June 1, 2018

Re: Site Specific Investigation
Upland Heights B5
Technical Review

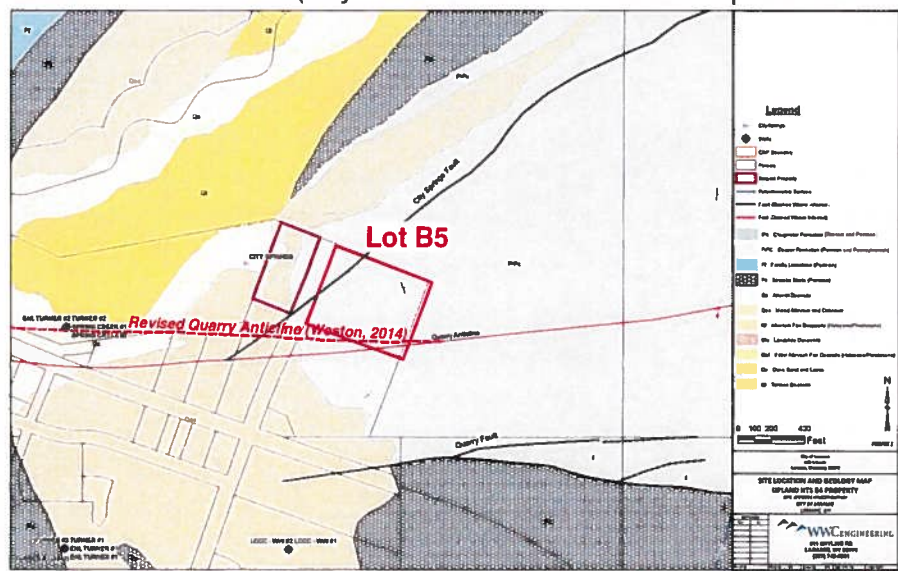
WWC identified three structural features near Upland Heights B5 Lot – two faults (City Springs and Quarry Faults) and a structural fold (Quarry Anticline). The Quarry Fault is well outside of the required vulnerable feature setback distance of 100 feet (City of Laramie Unified Development Code, subsection 15.08.040.A.7(b)). WWC has indicated that the City Springs fault cuts through the northwest quarter of the lot. The third feature, the Quarry Anticline hinge, is described in the WWC SSI report as crossing the southeast corner of the lot. Based on field work performed by Weston Engineering, they proposed that the fold axis of the Quarry Anticline may actually be located further to the north than that mapped by Ver Ploeg (2009) as shown in the adjacent figure. This

placement of the fold axis would bisect most of the southern section of the lot, and as described by WWC, results in the north limb of this structural fold encompassing a majority of Lot B5.

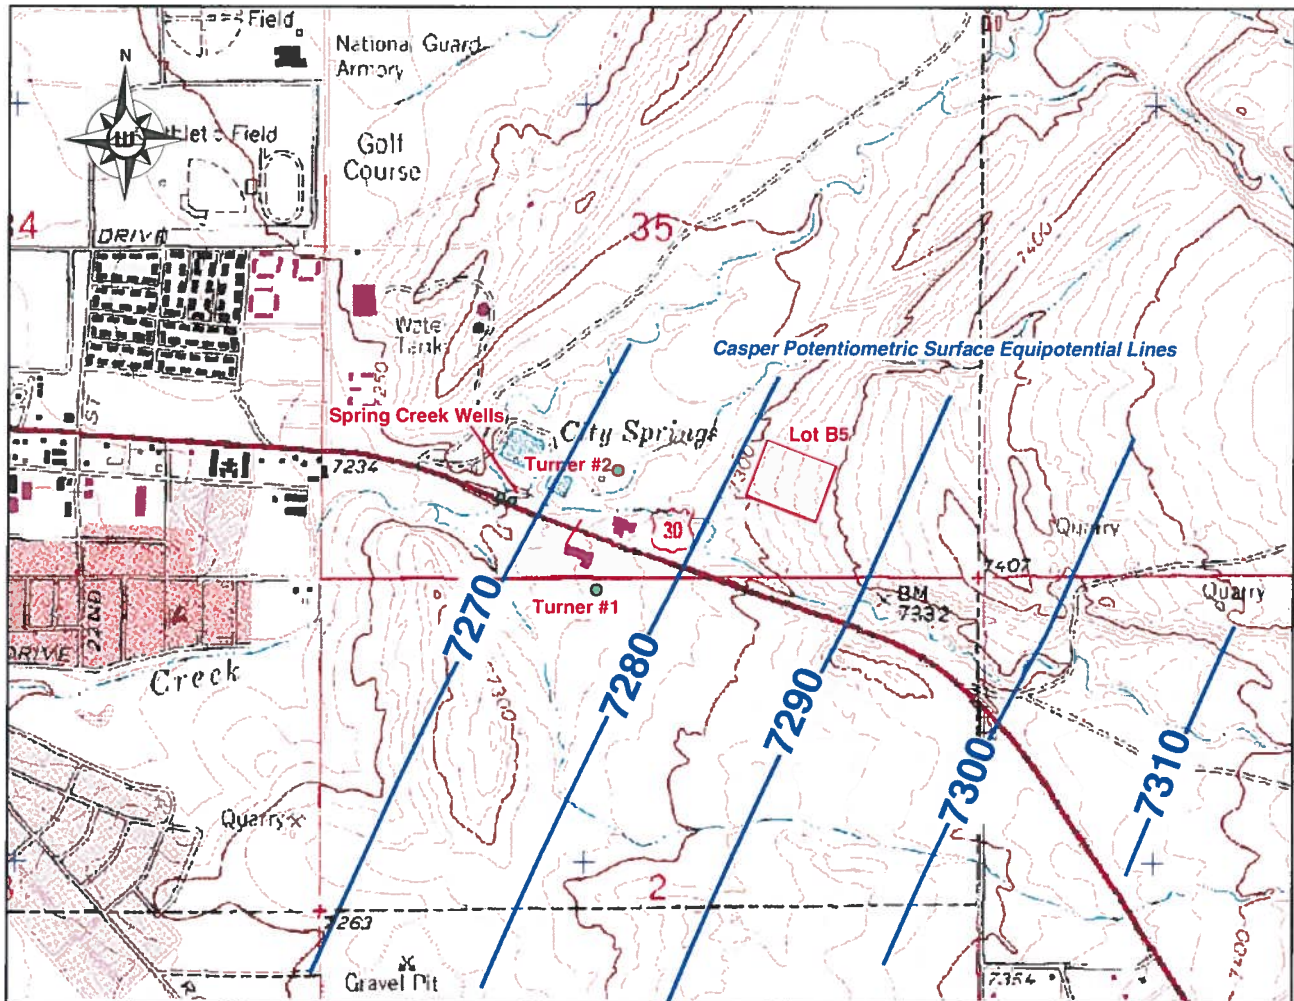
WWC's potentiometric surface map for the Casper Aquifer is very limited in data. There is only one equipotential line visible in the very southeast corner of Figure 1 which shows the 7,300 foot equipotential line for the Casper Aquifer potentiometric surface. Their narrative is correct in that with a surface elevation of the subject property ranging from 7,314 feet to 7,332 feet that the depth to the Casper potentiometric surface will range between 30 and 50 feet. The figure on the following page was developed by the author of this review from several previous studies in the area and it depicts the potentiometric surface a little more definitively than that shown by Figure 1 in WWC's SSI report.
